ADDENDUM NUMBER ONE

DATE OF ISSUANCE: August 16, 2019 **PROJECT NUMBER:** 19028

PROJECT: Snowbasin Clinic
3925 Snow Basin Road
Huntsville, Utah 84317 **ARCHITECT:** JRCA Architects, Inc.
577 South 200 East
Salt Lake City, Utah 84111

MECHANICAL ADDENDUM 1

1 MAIN LEVEL WASTE AND VENT PLUMBING PLAN
 SCALE: 1/4" = 1'-0"
 PROJECT NORTH

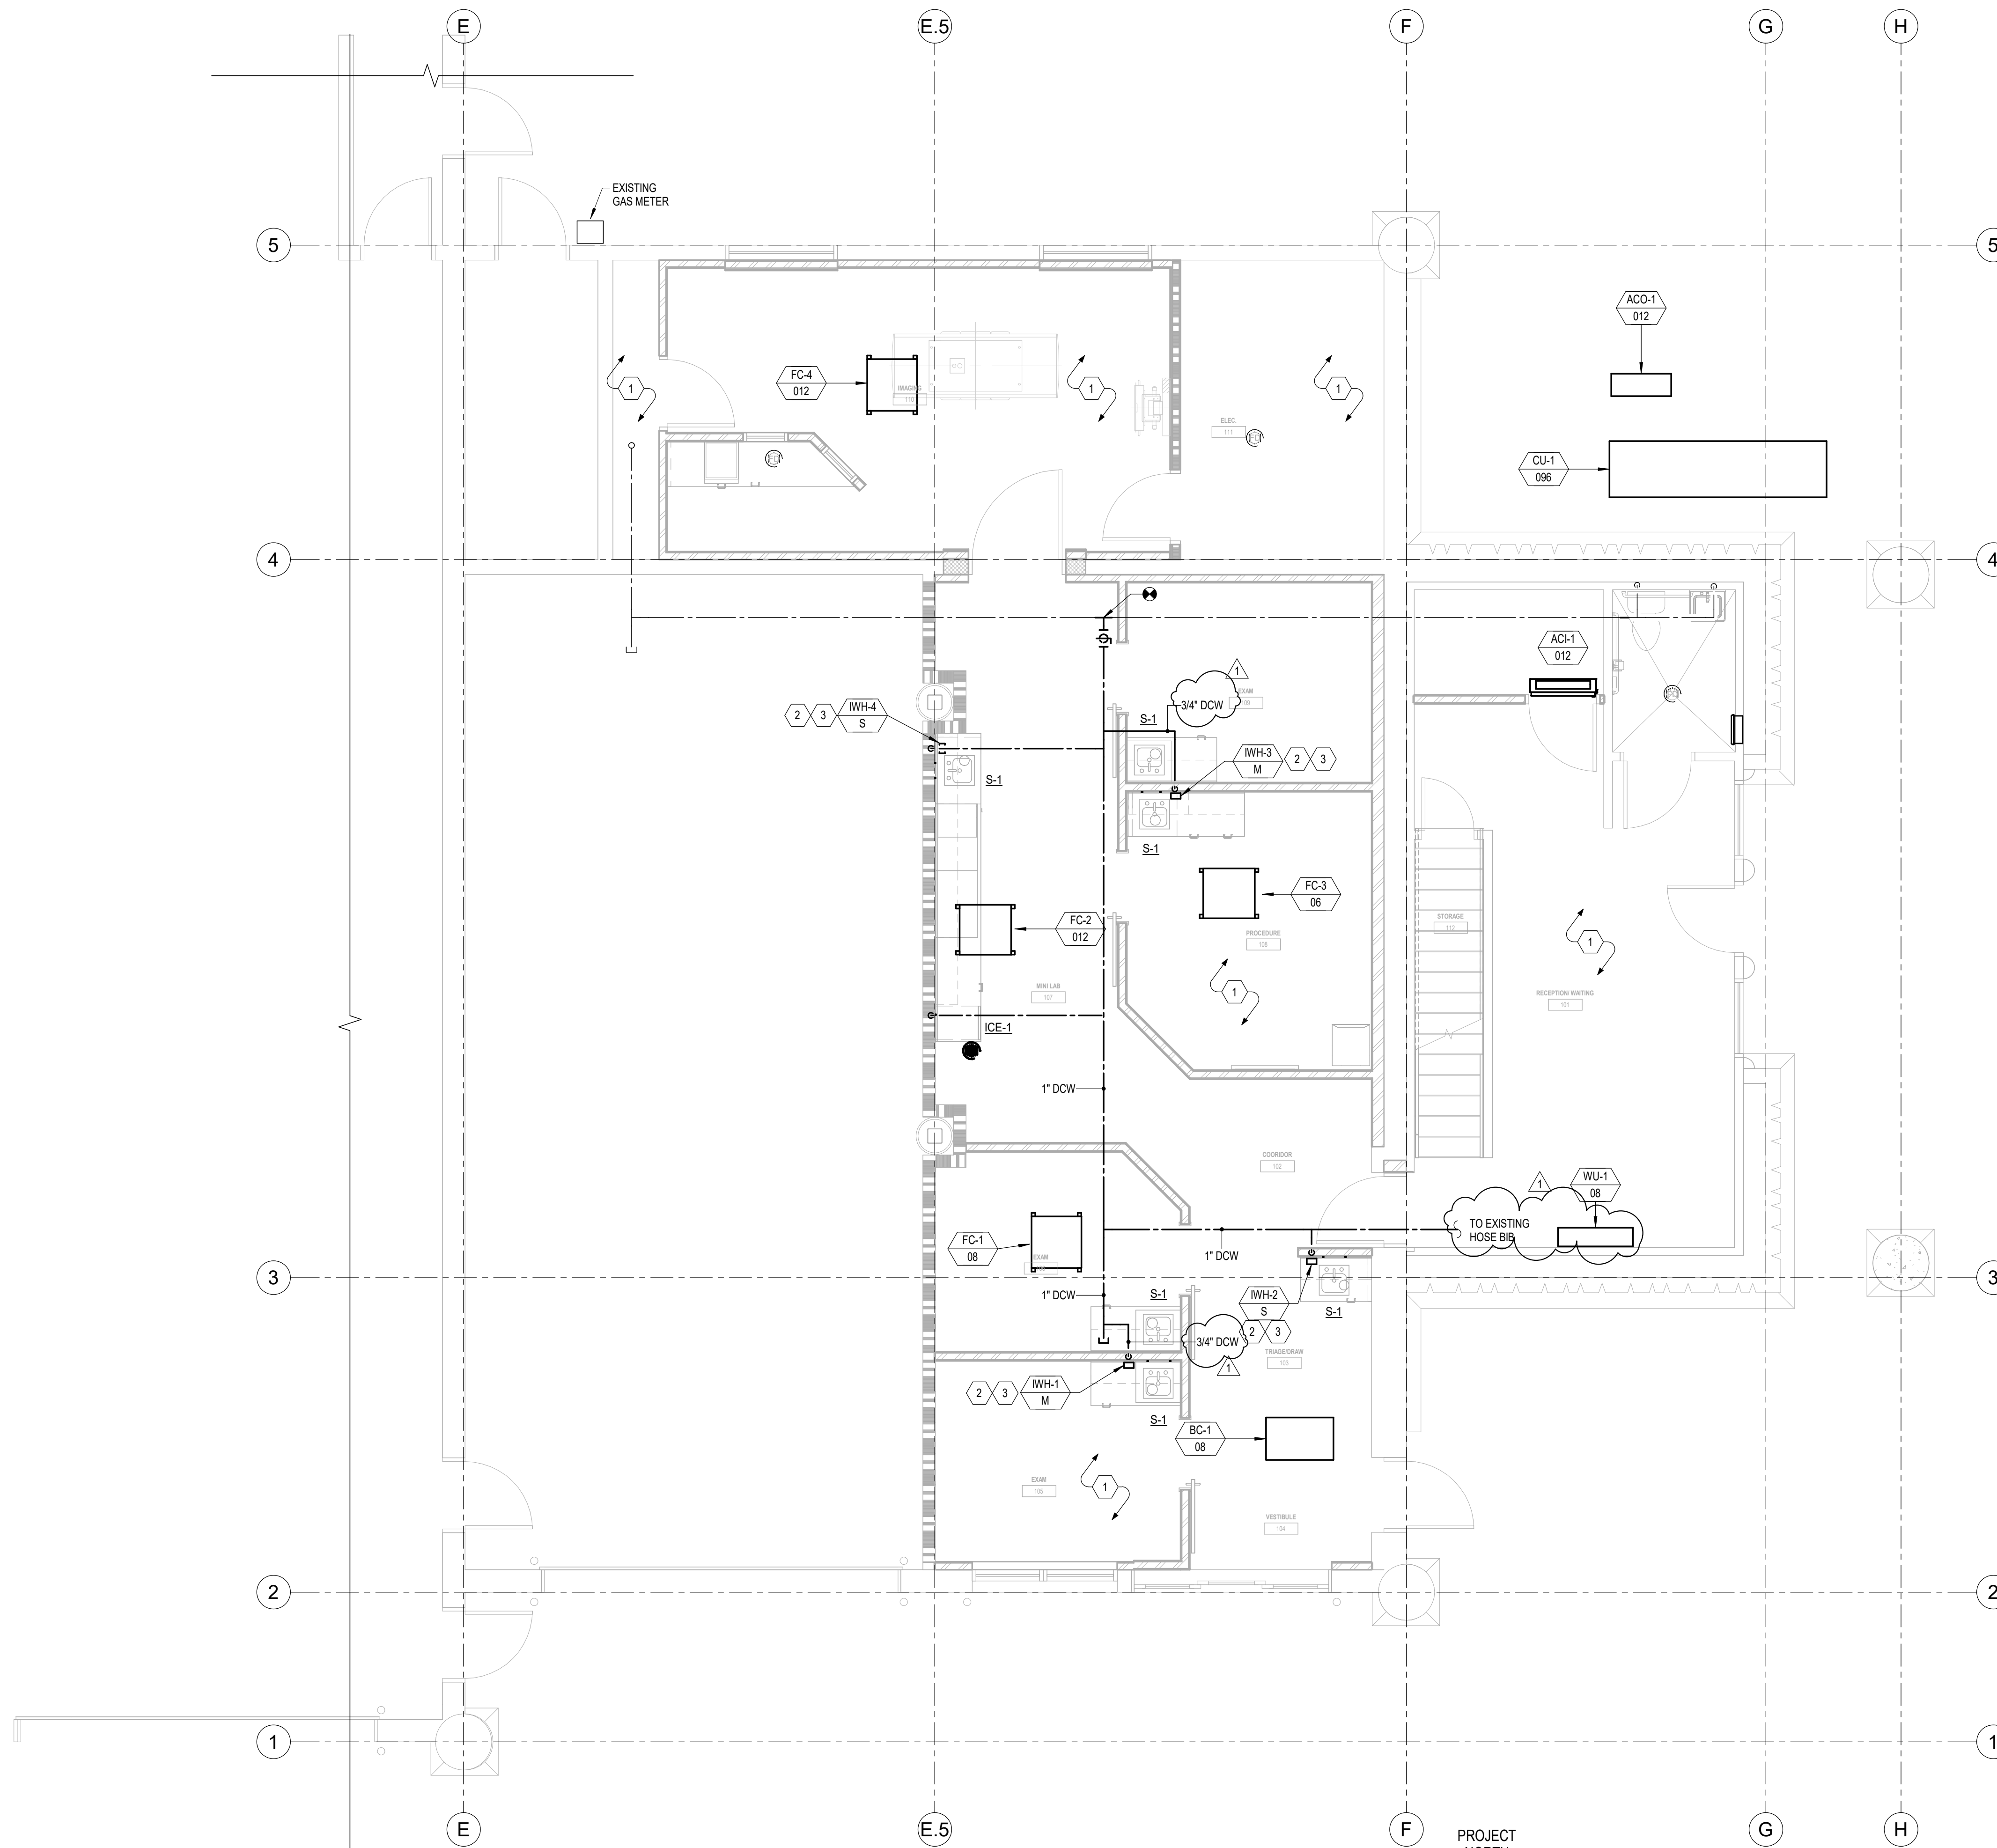
1. Refer to attached for modifications to notes and pipe sizes.

1 LEVEL 1 LIGHTING PLAN
 EL101 1/4" = 1'-0"

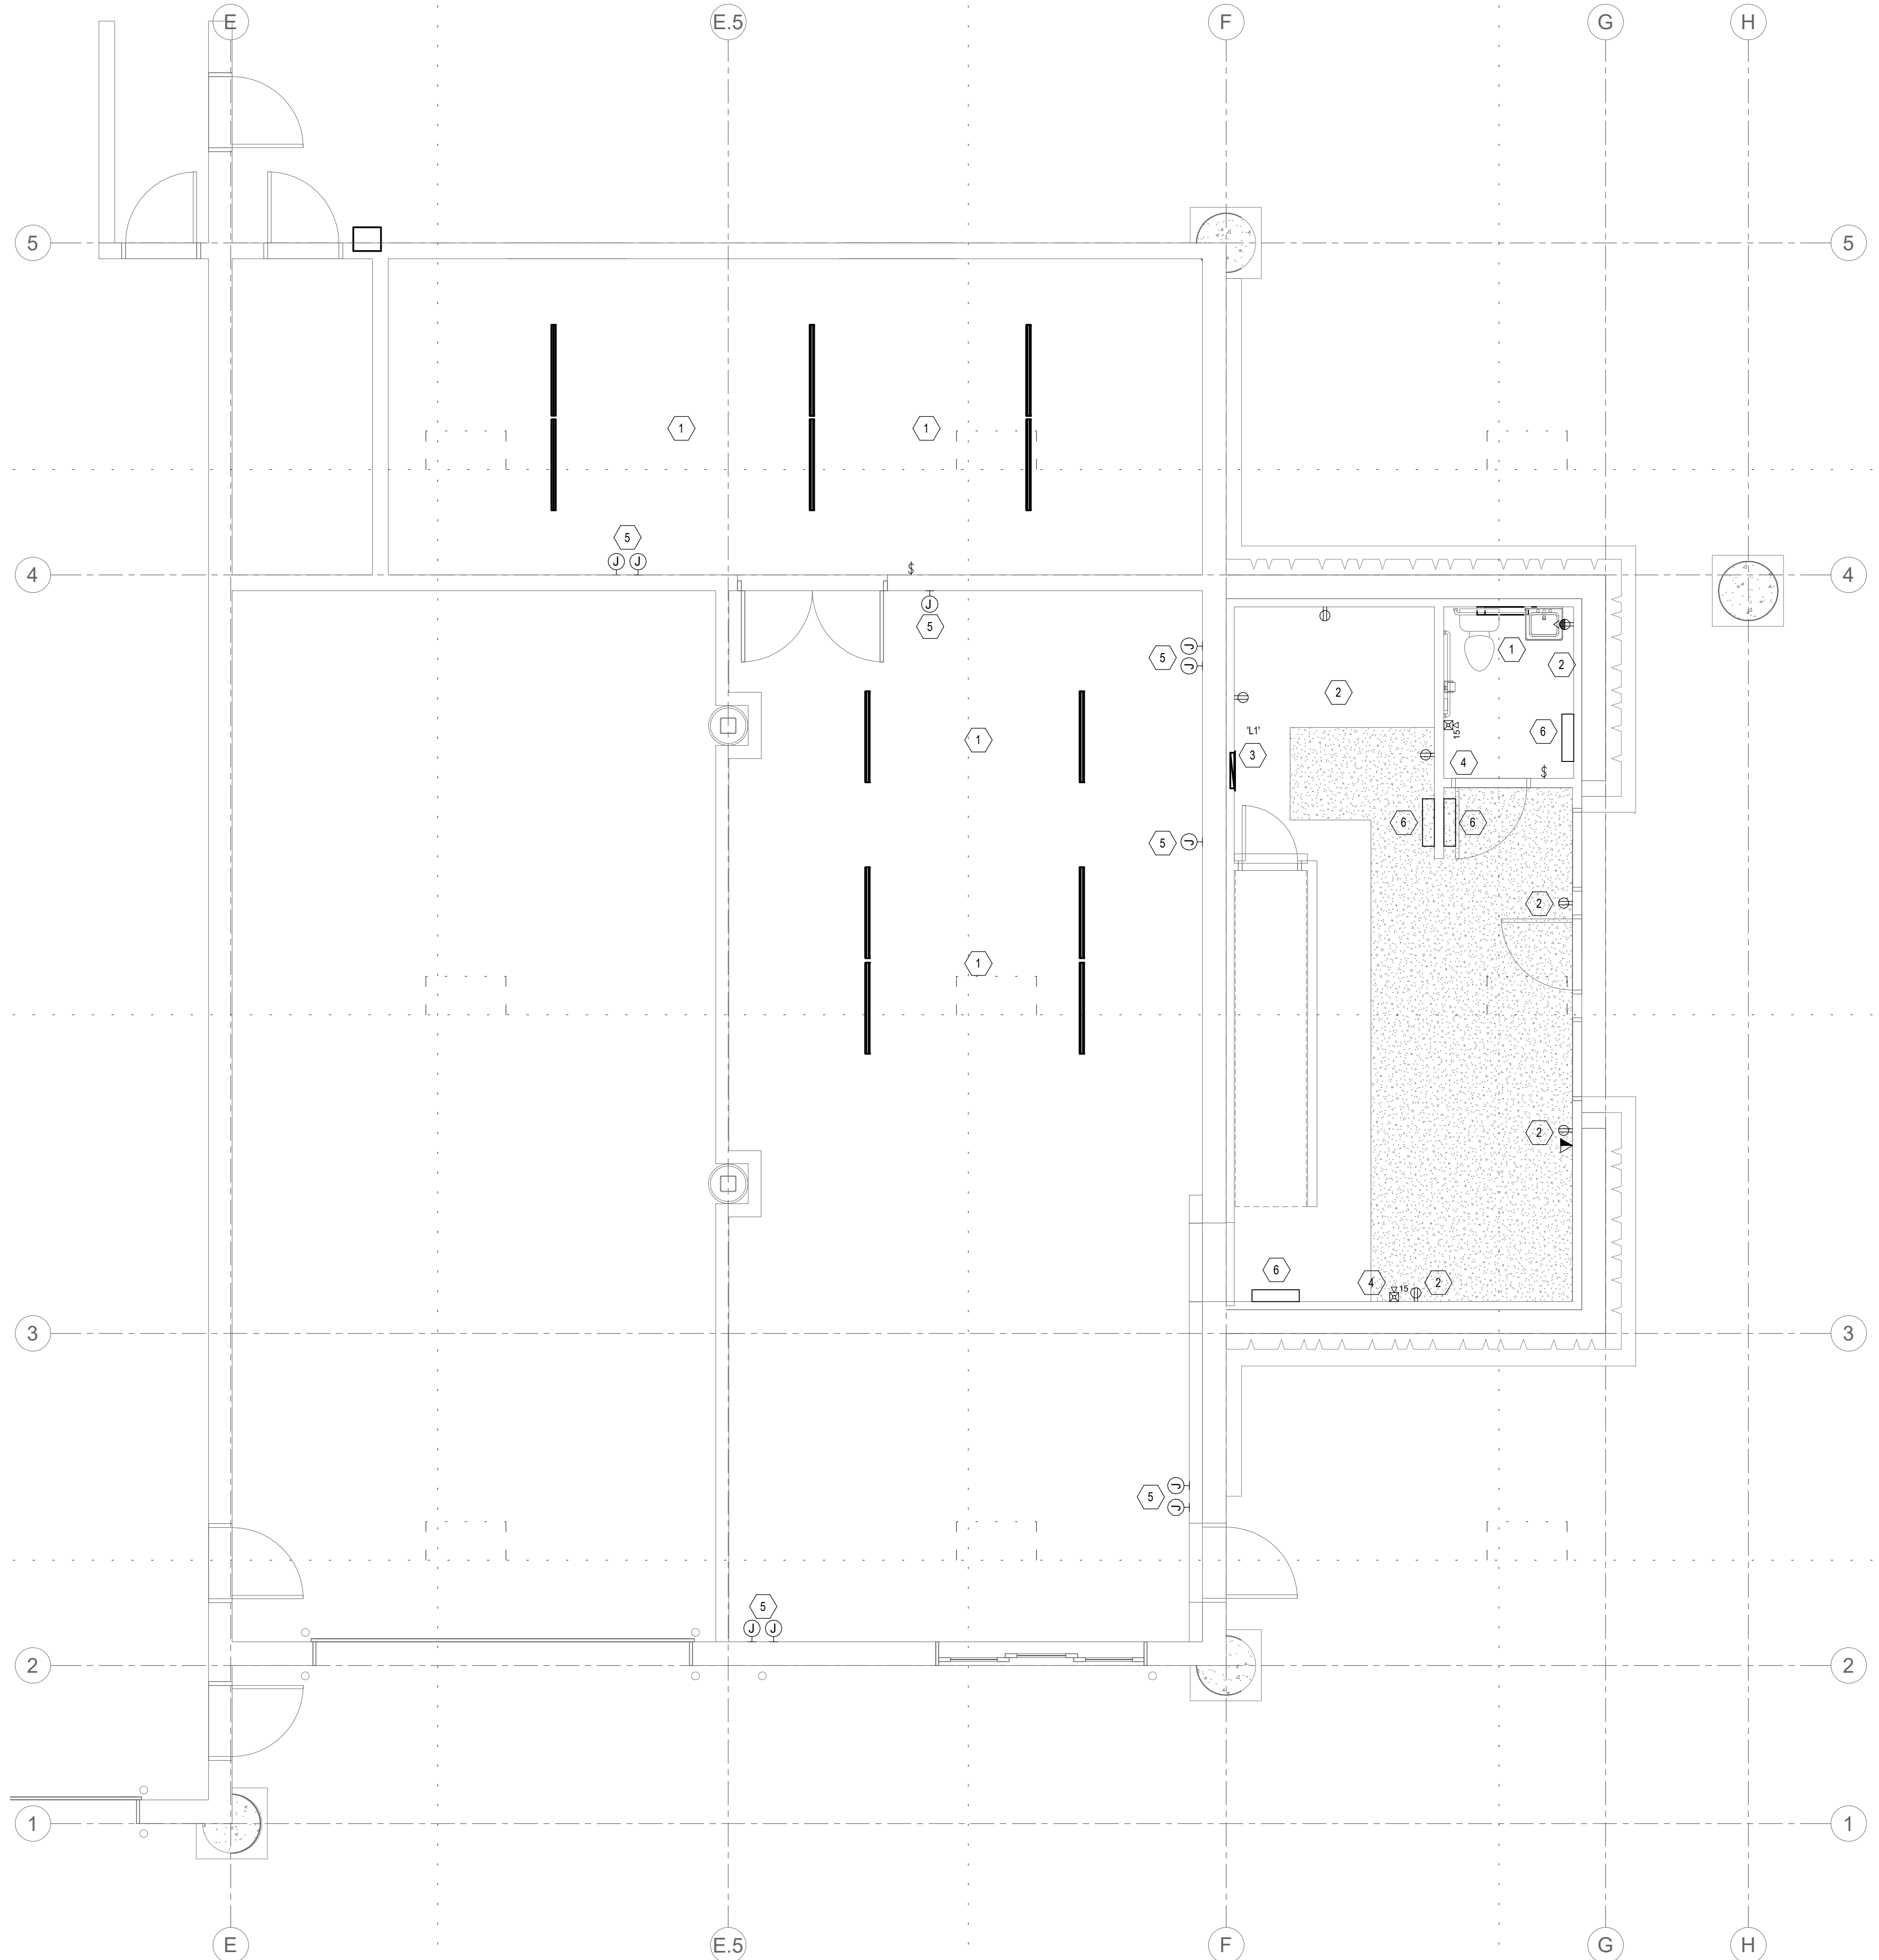
1. Change fixture types in Reception to AF and AFE.
2. Delete (2) type A fixtures in IT room and add (1) type B fixture.
3. Add dimming switches and dimmer module in Imaging 110. Add keyed note 6.
4. Circuit exam light in Procedure 108 to room lighting circuit. Add keyed note 7.

1 LEVEL 1 POWER PLAN
1/4" = 1'-0"

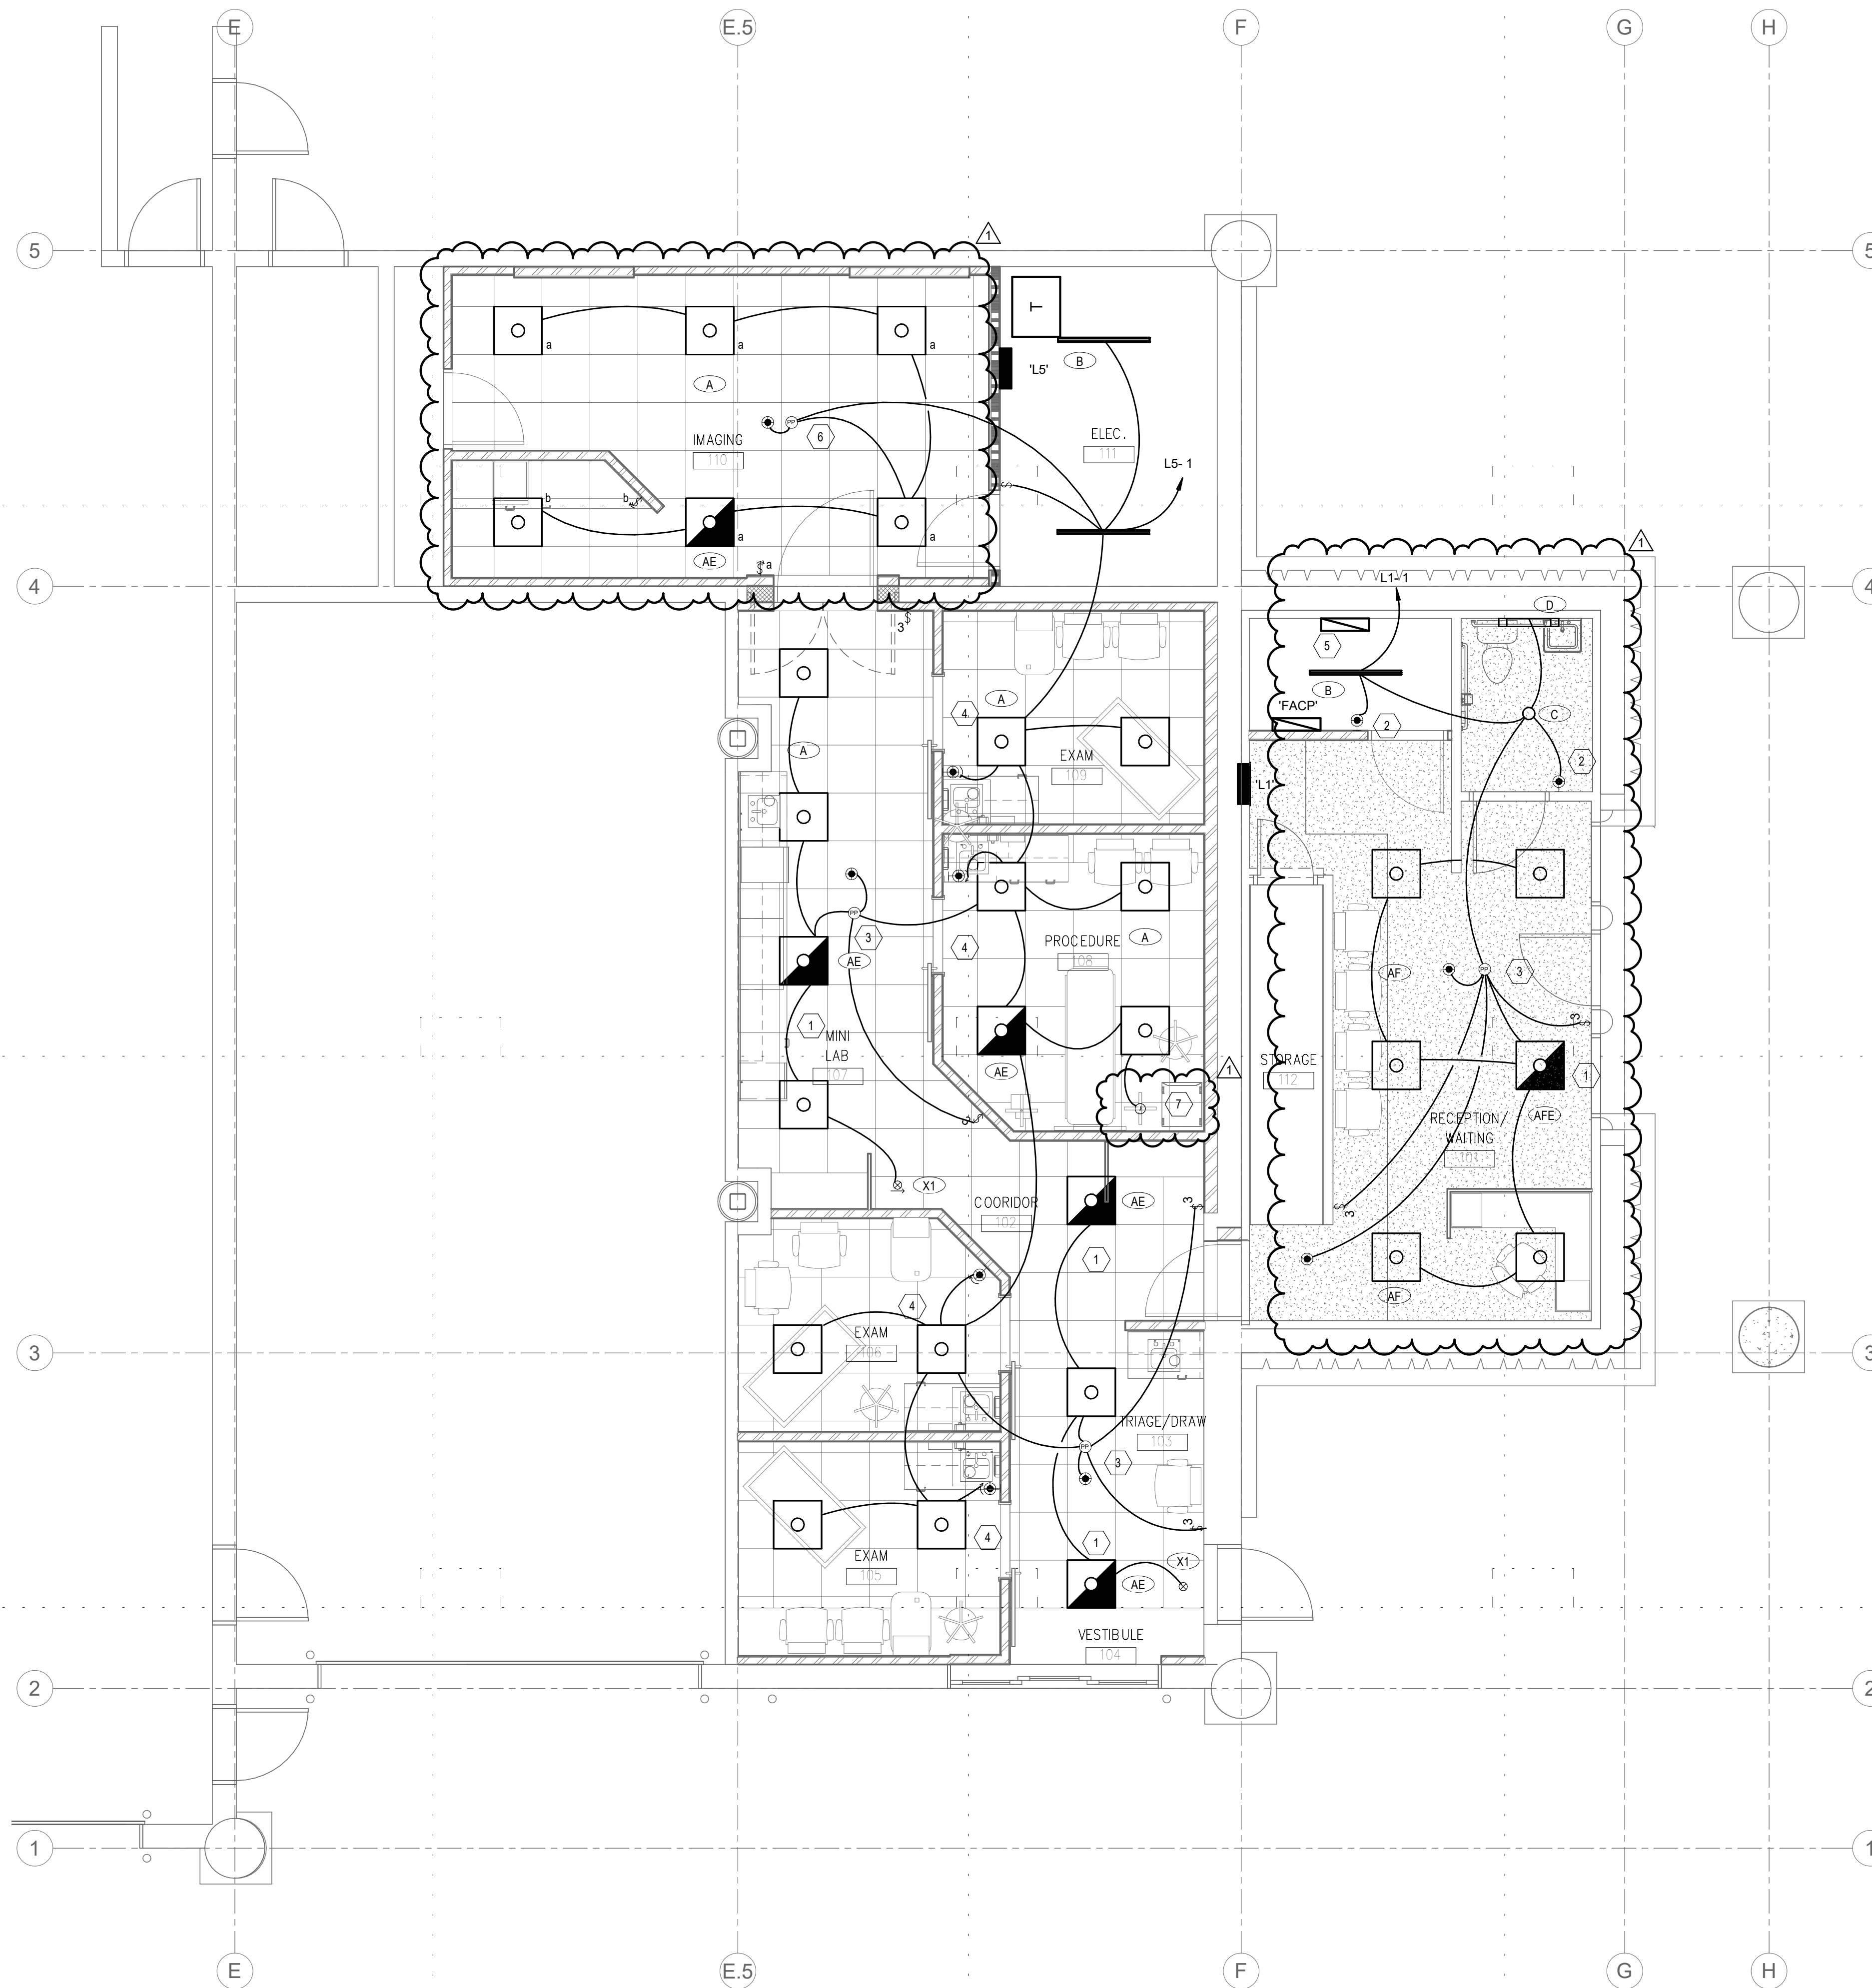
1. Delete Panel L6.
2. Add power and data for two wall mounted TV monitors.
3. Add ceiling mounted data outlet for wireless access point.
4. Relocate data outlets in exam rooms to opposite wall.
5. Relocate the new fire alarm panel to the IT room.
